STAFF REPORT
KETCHUM PLANNING AND ZONING COMMISSION
MEETING OF AUGUST 24, 2021

PROJECT: Crossbuck McNee Townhomes

APPLICATION: Design Review and Townhouse Subdivision Preliminary Plat

Sheet No:
L1.0

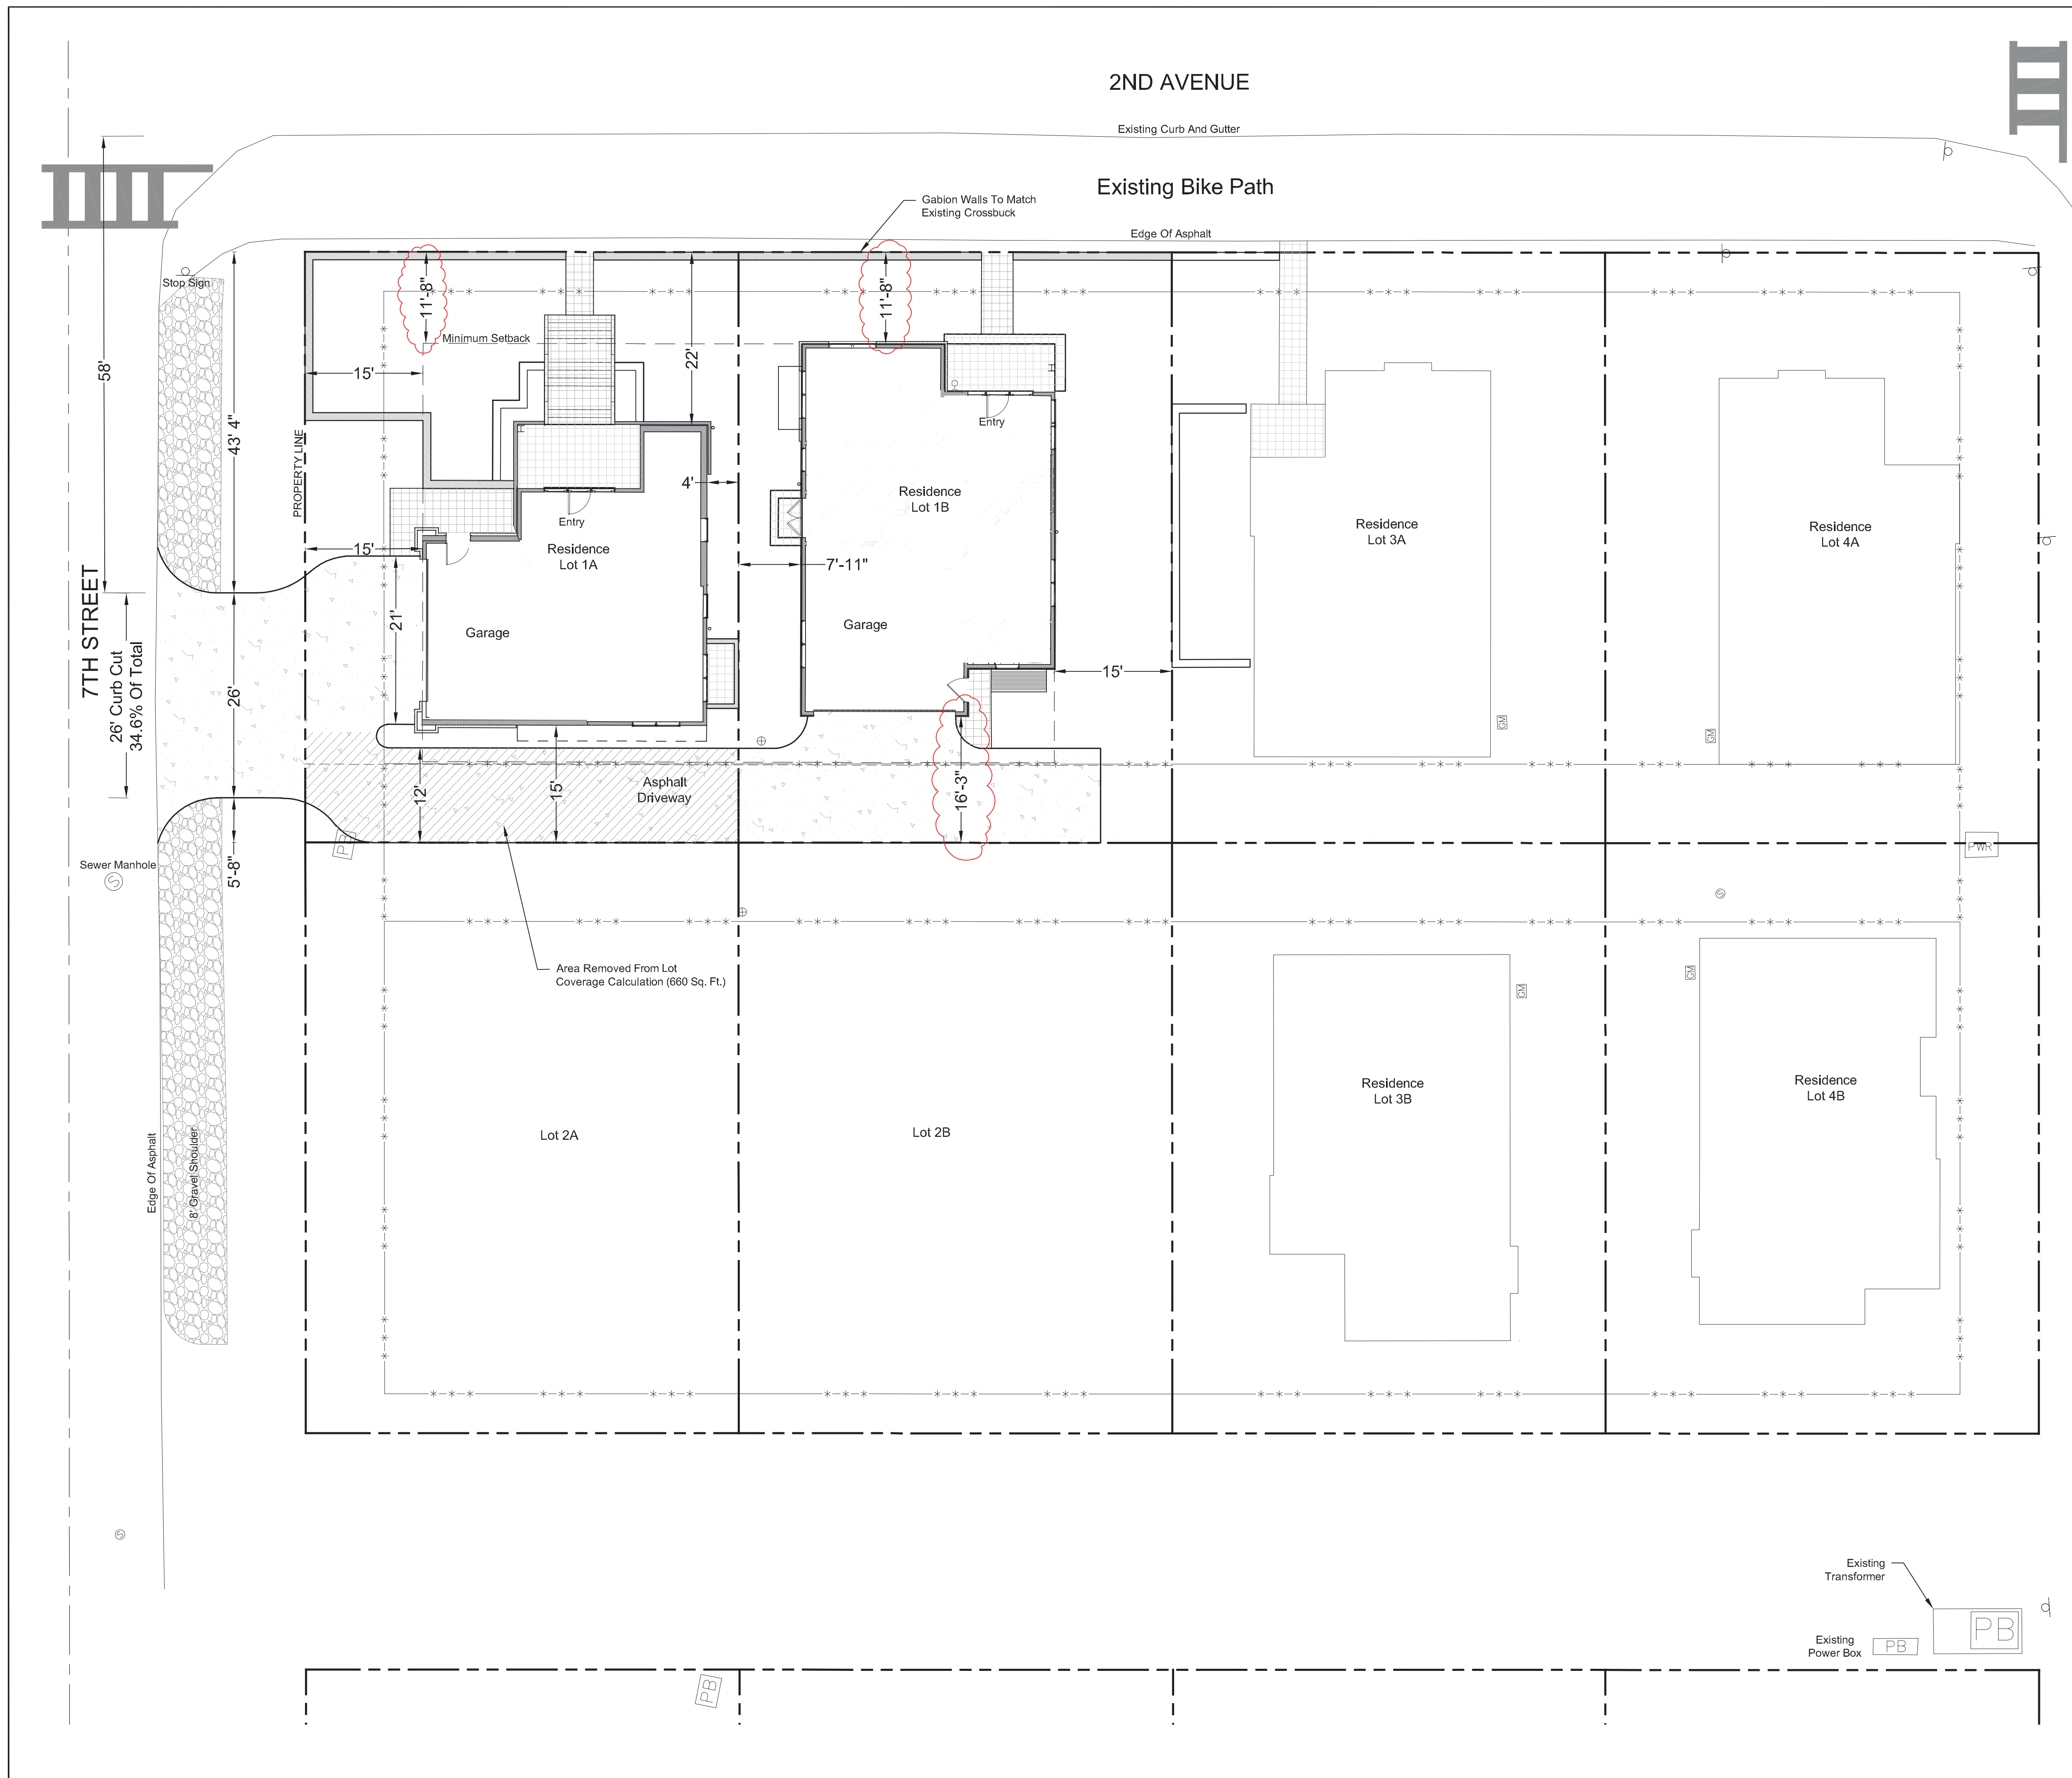
The site plan on Sheet L1.0 shows three stairs encroach within unit A's required setback from 2nd Avenue. These stairs are not permitted within the required side setback area.

All structures are subject to setbacks. Structures include anything permanently constructed in or on the ground (KMC §17.08.020). The only elements not qualified as structures are fences less than 6 feet in height, decks less than 30 inches above grade, paved areas, and structural or nonstructural fill (KMC

§17.08.020). Pursuant to Ketchum Municipal Code §17.08.010.F, a “building” or “structure” includes any part and includes all other structures of every kind regardless of similarity to buildings. The proposed stairs are qualified as a structure and are subject to the setbacks required in the GR-L Zone.

Below grade structures may encroach into required setbacks subject to the standards specified in Ketchum Municipal Code §17.128.020.K. The proposed stairs do not meet these required standards.

Staff has added a recommended condition of approval that the stairs within unit A’s required setback from 2nd Avenue be removed from the project plans.

3. The applicant shall remove the stairs that encroach into townhome unit A’s required setback from 2nd Avenue.
4. This Design Review approval is based on the plans and information presented and approved at the meeting on the date noted herein. Building Permit plans for all on-site improvements must conform to the approved Design Review plans unless otherwise approved in writing by the Planning & Zoning Commission or the Administrator. Any building or site discrepancies which do not conform to the approved plans will be subject to removal.
